MEMORANDUM

DATE: November 15, 2002
TO: Montgomery County Planning Board
VIA: Joe R. Davis, Chief
Development Review Division
FROM: Michael Ma, Supervisor
(301) 495-4523

REVIEW TYPE: **Amended Site Plan**
CASE NUMBER: **8-81084A**
PROJECT NAME: **Pepsi Bottling Warehouse, Briggs Chaney Industrial Park, Parcel C**
APPLYING FOR: Approval of 11,823 square feet of warehouse/loading area addition
REVIEW BASIS: Division 59-D-3, Montgomery County Zoning Ordinance

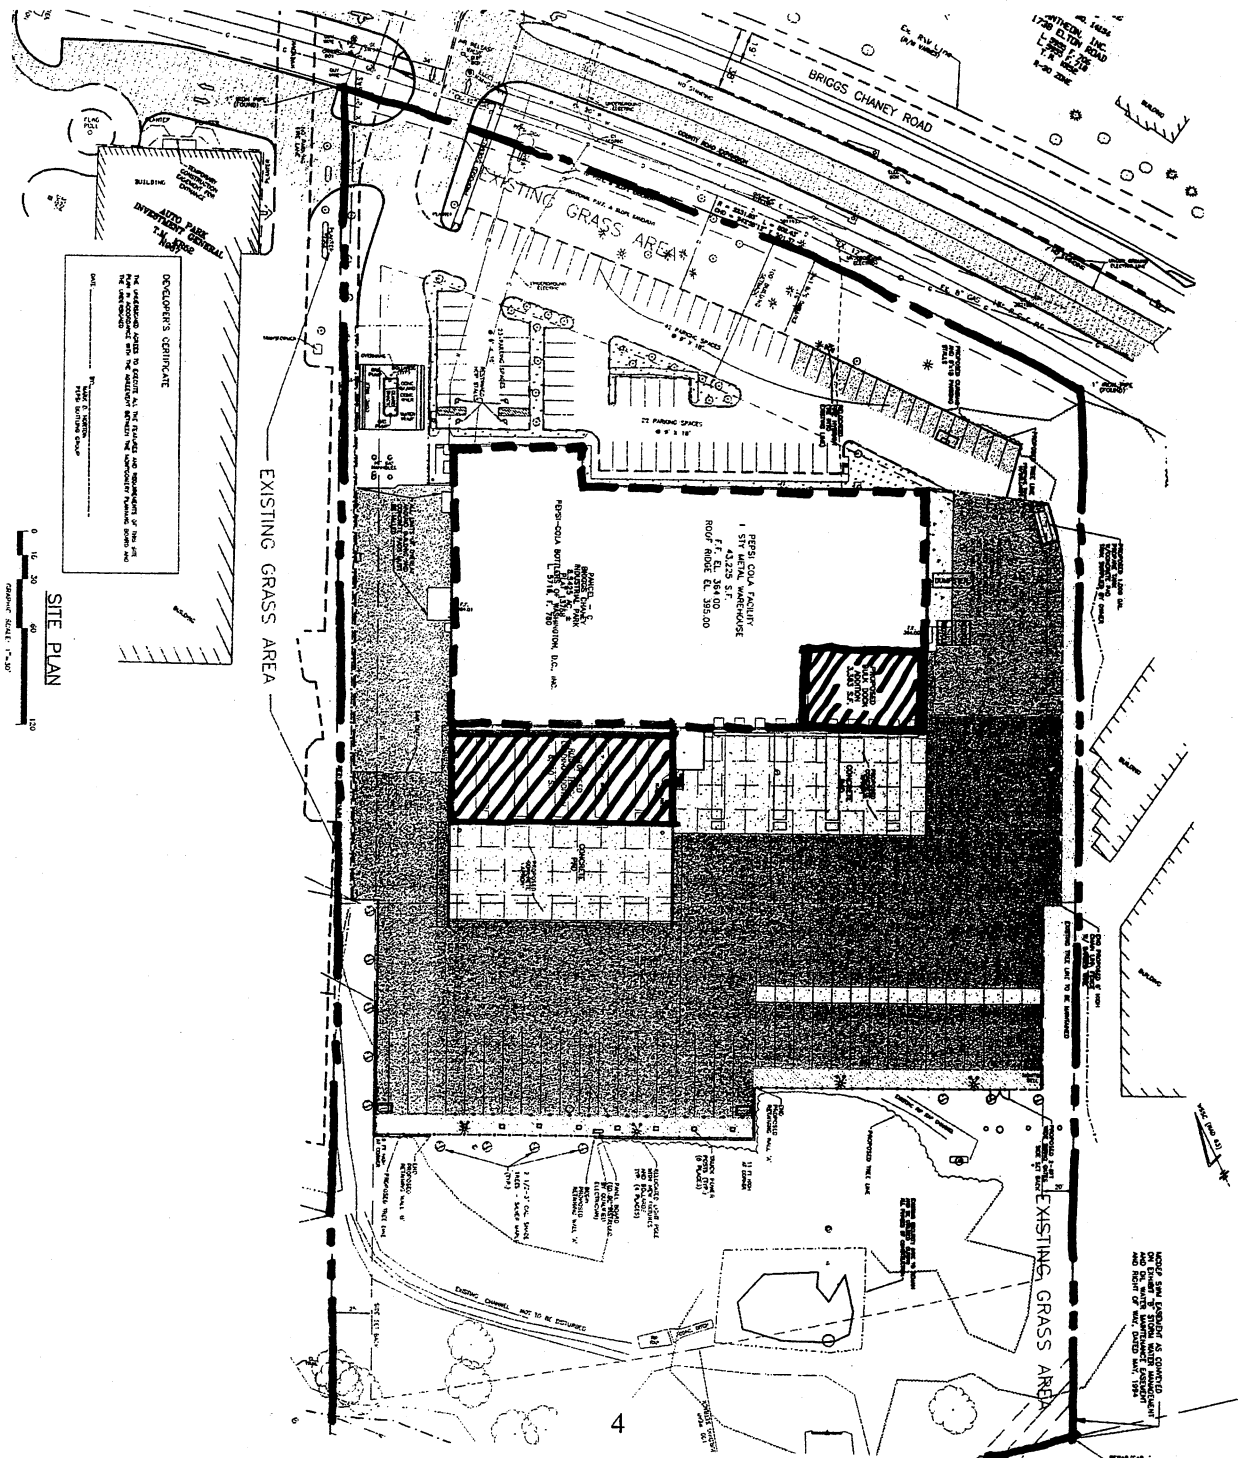
The amended site plan application proposes a 3,363-square-foot bulk dock addition at the southeastern corner of the existing warehouse building and an 8,460-square-foot route truck loading addition to the southwestern corner. In addition, the existing truck parking area will be expanded about 400 feet to the south. Briggs Chaney Road is planned as a four-lane divided arterial. The construction of the road widening for this section of Briggs Chaney Road will begin in the spring of 2003 as a County capital improvement project. A bikeway and street trees along the frontage of this site will be included as part of the road improvement project. The applicant will install a lead-in sidewalk from the proposed bikeway to the development. The driveways off Briggs Chaney Road to the subject site and to the car dealership to the west will be combined into a share access drive on this site.
